Proposed changes to add verification to Clause 99:

Figure 99–4—Transmit Processing State Diagram

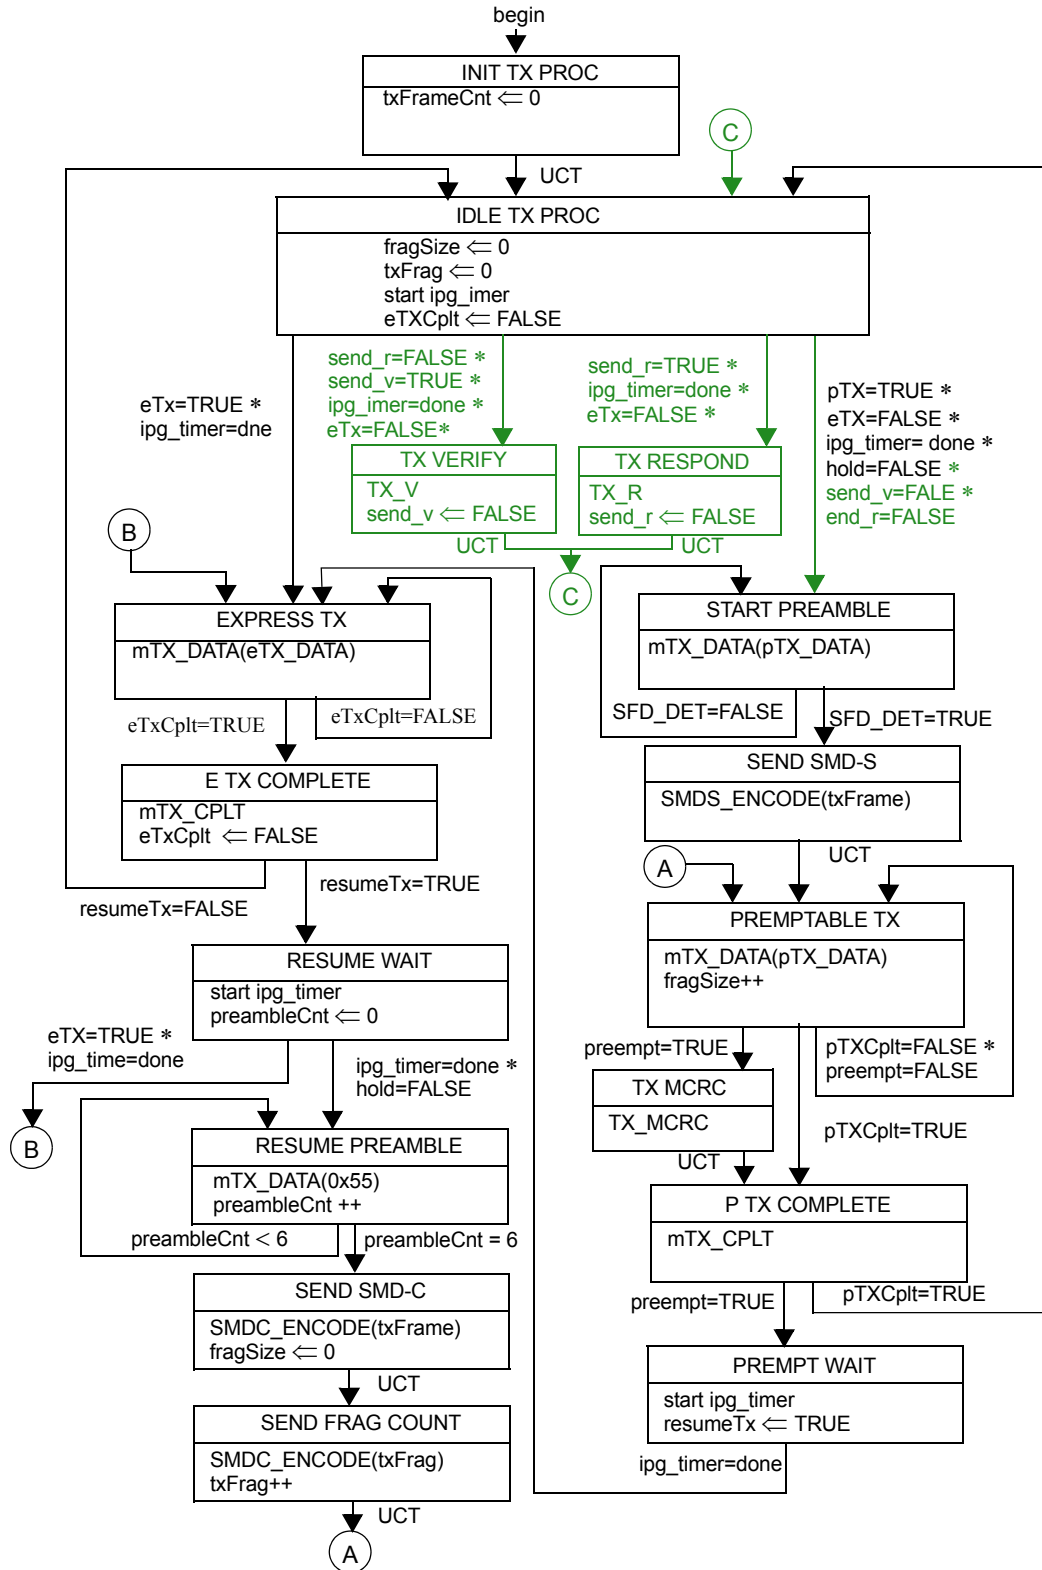
The Transmit Processing State Diagram is shown in Figure Figure 99–4. The Receive Processing State

Figure 99–5—Receive Processing State Diagram

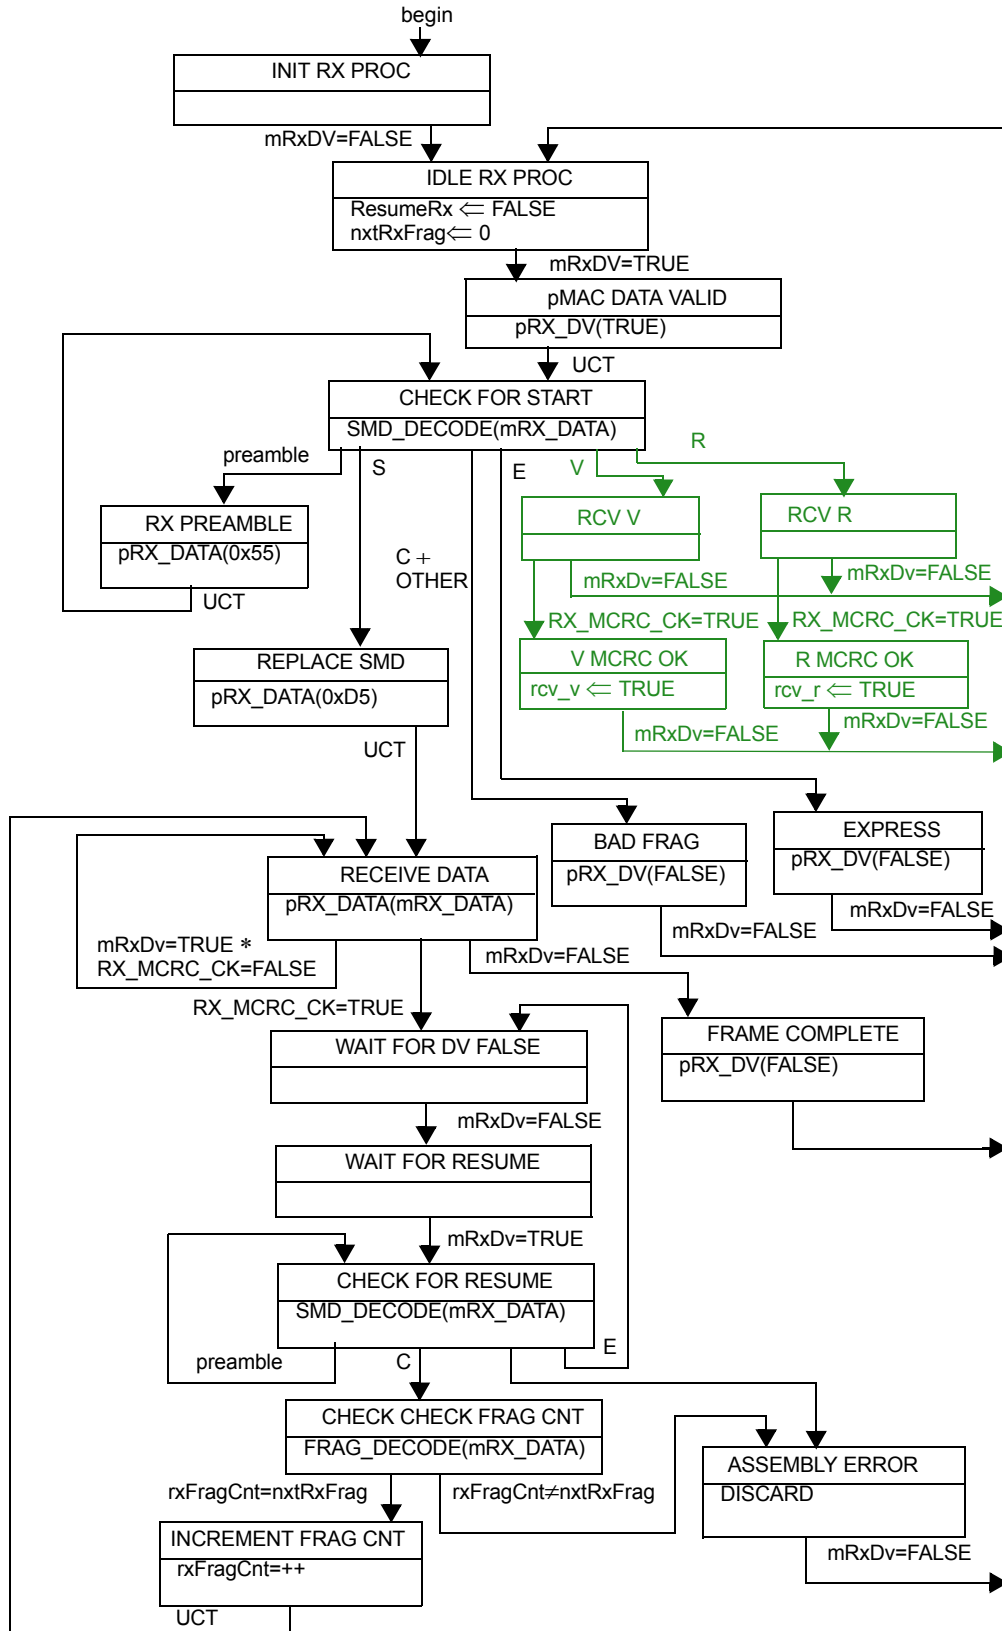
Diagram is shown in Figure 99–5. The Express Filter State Diagram is shown in Figure 99–6. [The Verify](#)

Figure 99–7—Verify State Diagram

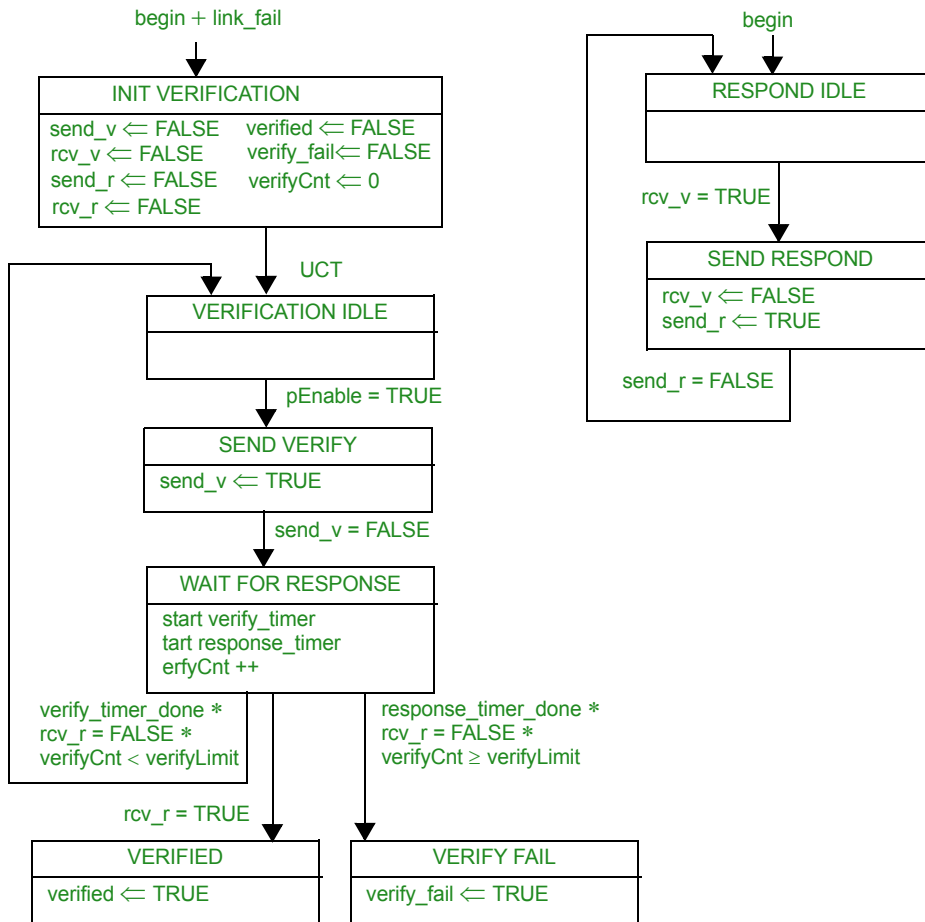
State Diagram is shown in Figure 99–7.
